# MAINTENANCE BULLETIN

COMMON SHELTER	FILE NO. 132-B	REVISION:
	DATE: 3/14/90	CATEGORY: INSPECTION
SUBJECT: INSPECTION OF DUAL CONTROL CARDS PART NO. 1642189-100	SYSTEMS AFFECTED: ALL

FIGURE 1

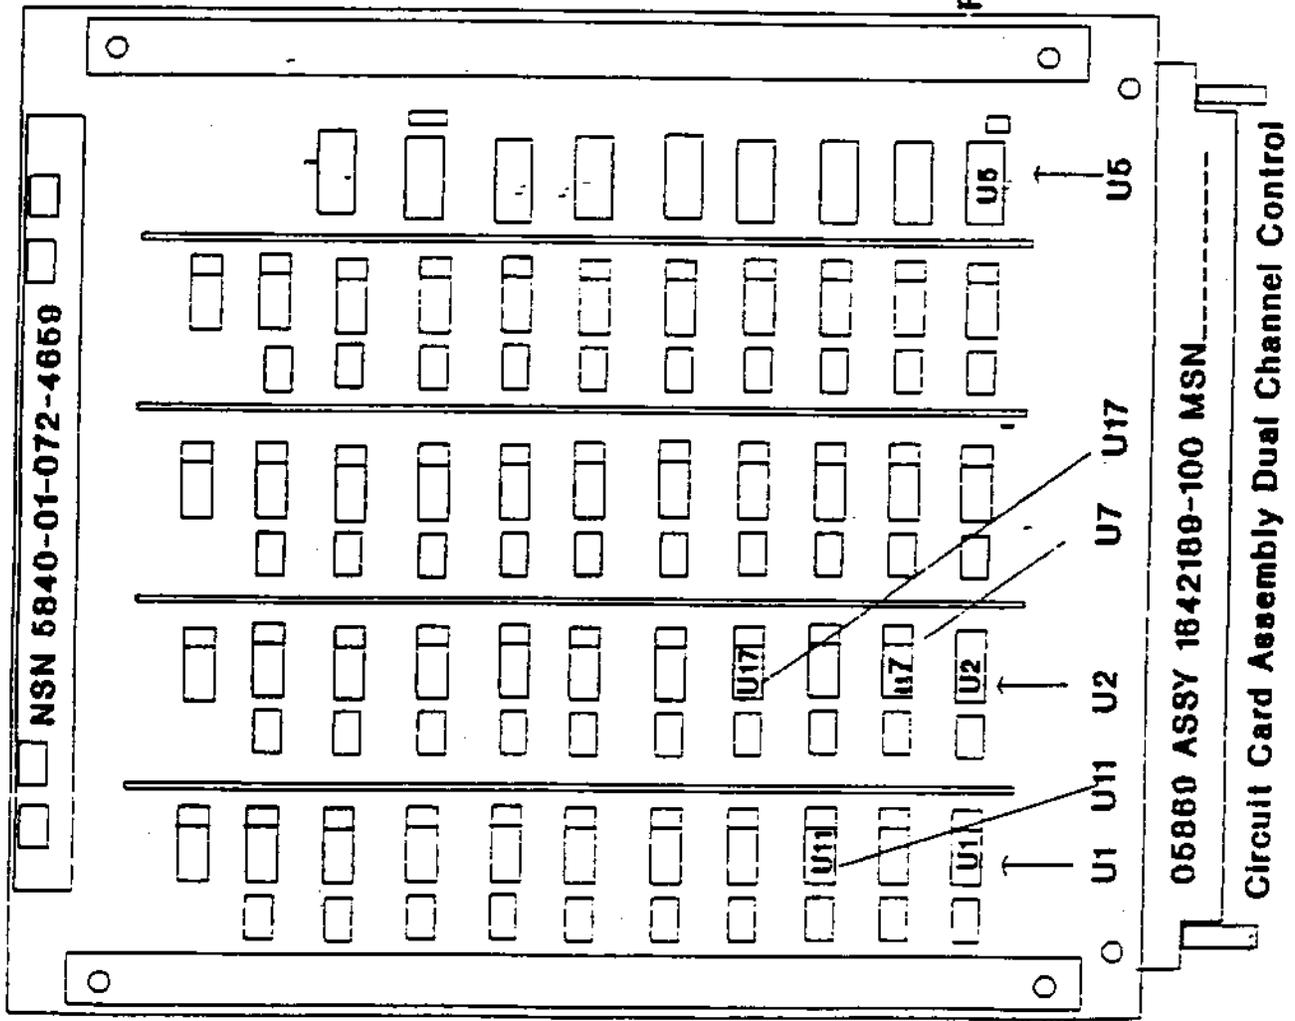
2. BACKGROUND: An unknown amount of 1642189-100 Dual Channel Control cards were built with improved 54LS257 microcircuits. This caused intermittent problems within the Radar System. Cards received by the General Support (GS) Shops and Sacramento Army Depot for repairs should contain the unimproved component for U1, U2, U5, U7, U11, and U17. (See attached figure 1 for location of components.) Following is a list of the unimproved components part numbers:

a. During the Initial Inspection for repairs of the Dual Channel Control Card (1642189-100) the technician will inspect the 1642189-100 cards to ensure that they contain the unimproved components listed in paragraph 2 above.

b. If the inspection reveals that any other than the part numbers listed above is found in the indicated locations, then the repair tag should be annotated with a remark to indicate that the card will need to be re-identify with part number 1708261-100 after repairs are completed.
